From: [REDACTED]
To: [REDACTED]
Sent: 2/24/2021 9:16:37 AM
Subject: RE: O8W-PM 35217268, 35224712, 35224713 - Bucks Creek 1101 Phase 1,2&3 - Pre-Engineering Meeting

Subject: O8W-PM 35217268, 35224712, 35224713 - Bucks Creek 1101 Phase 1,2&3 - Pre-Engineering Meeting

PM 35217268 (Phase 1)

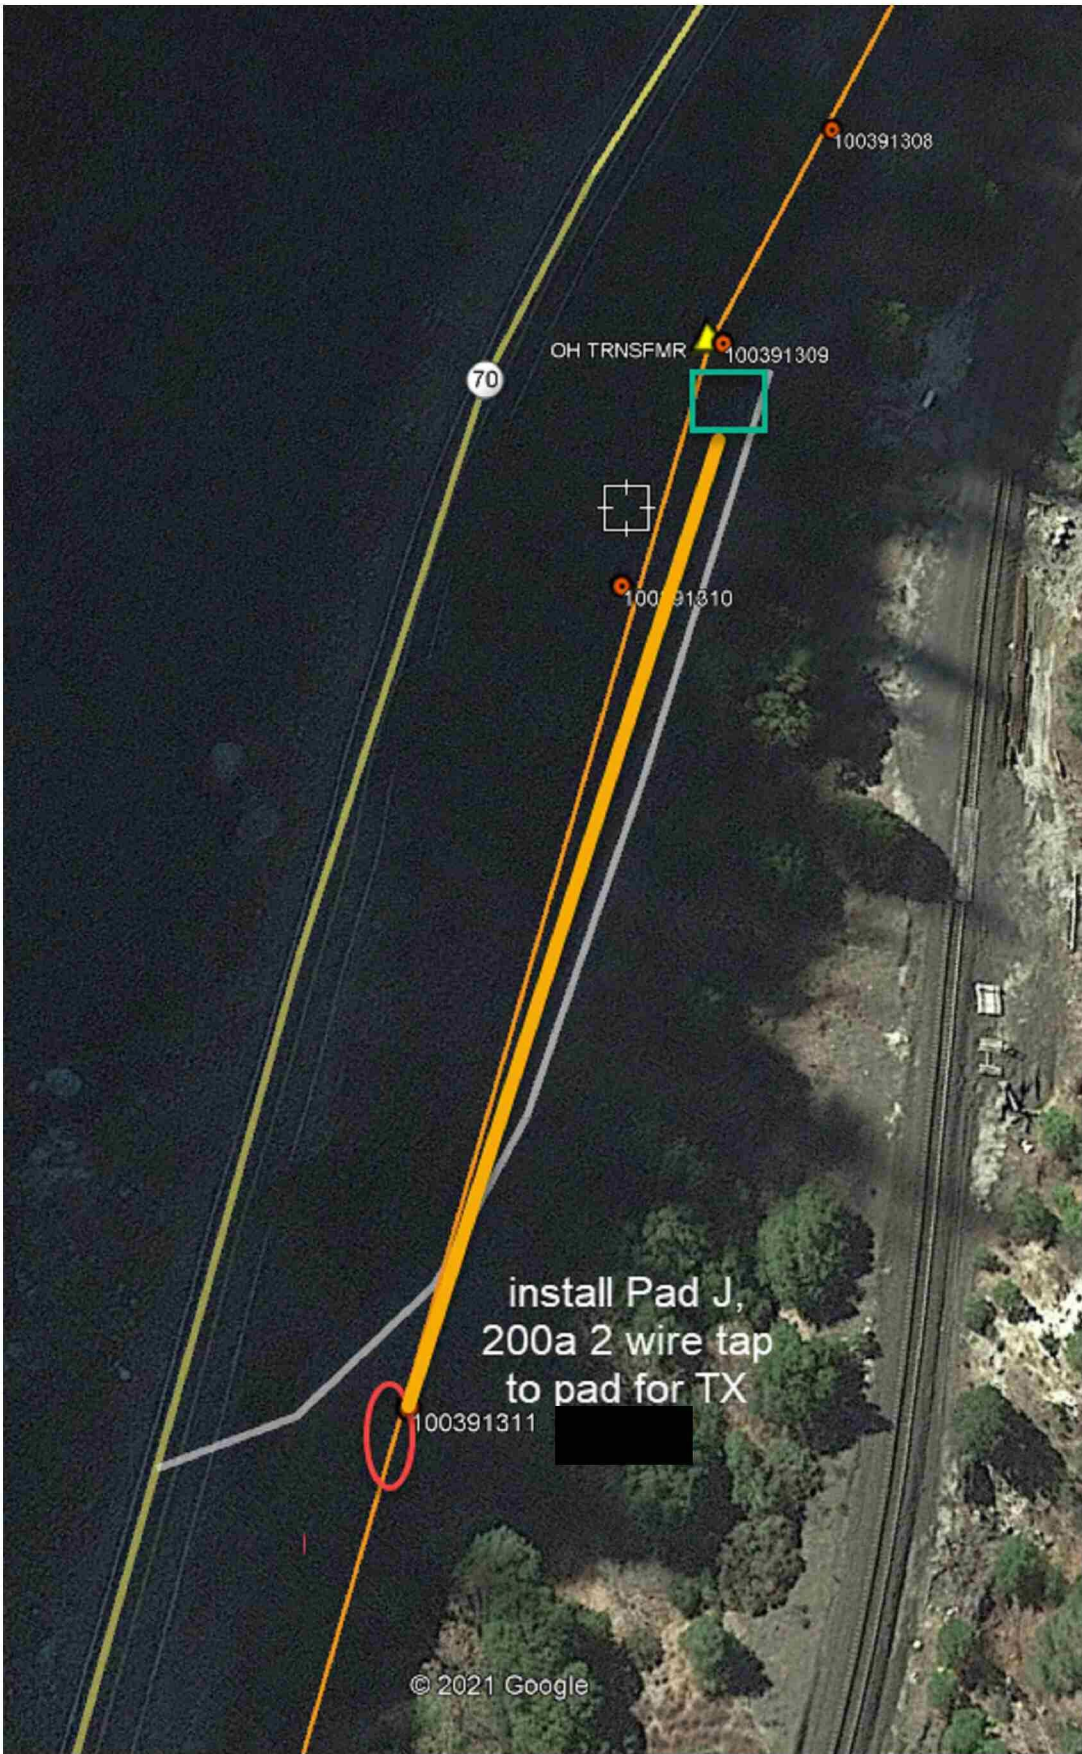
Your outlet red-line Bucks Creek looks close to what I was thinking. Need to work with [REDACTED] to get this designed with a single 6" and use #5 boxes with 200A cable. There is not a reason this will need (2) 6" and 1-4" and 7 boxes. There is probably only 20a peak on the primary now.

Before we involve [REDACTED] it would be good to scope with the estimator so we can address the local folks with a somewhat solid plan. If we can establish the outlet for Bucks Creek Sub + the TX locations for Cresta Dam and [REDACTED] that should take most of the questions away. Rock Creek Bridge is the only thing I saw a big issue with. The local guys can help us once we determine what we are doing and make sure we get the details correct for permit.

Also need to see what Hydro is willing to do with the TX for the penstock metering valve at Rock Creek PH. It will be a long way up from the

Need to see if Hydro has GPR data for the Hwy 70 road bed to see if we can get 42" minimum cover and keep clearance over any hydro facilities.

Merlin can go back like we just did [redacted] Poe. Pad on the Highway and tension secondary 1/0 ASCR across the river. We can negotiate to move the [redacted] service point with my MSA electrician.

we can serve [redacted] Merlin with either circle, OH 1/0 ASCR triplex tension across the river.

Should be able to take a pad here and get the dam a UG service. For [redacted] riser up and go in the back of the

first tunnel window, leave the old TX pole, top it and use to splice in UG service feed.
